# **SPM:**

## **A Simple Power Management Proposal**

**By Pablo Brenner, LANNAIR Ltd.**

## **Frame Misordering:**

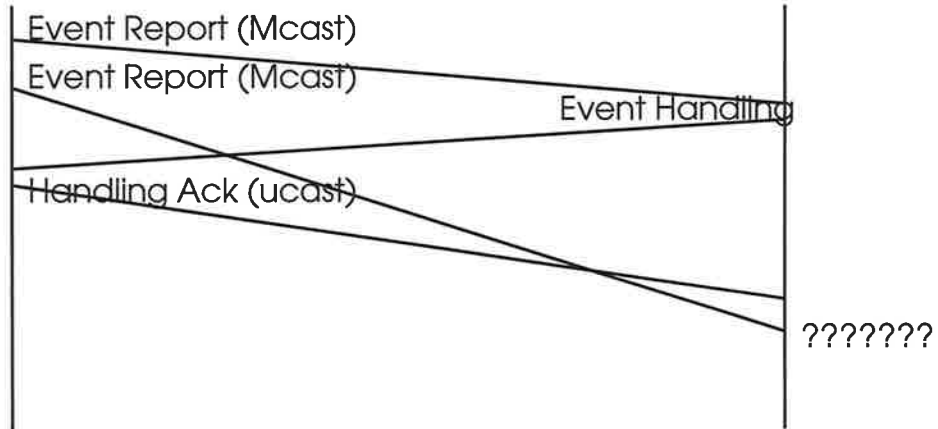
Multicast Messages and Unicast Message (to non-power saving stations) may arrive in reverse order.

"The service provided by the MAC Sublayer does not permit the reordering of frames transmitted with a given user priority"

"All Broadcast/Multicast frames shall be buffered", and  
"Frames destined to stations in the CAM or TAM mode shall be directly transmitted"
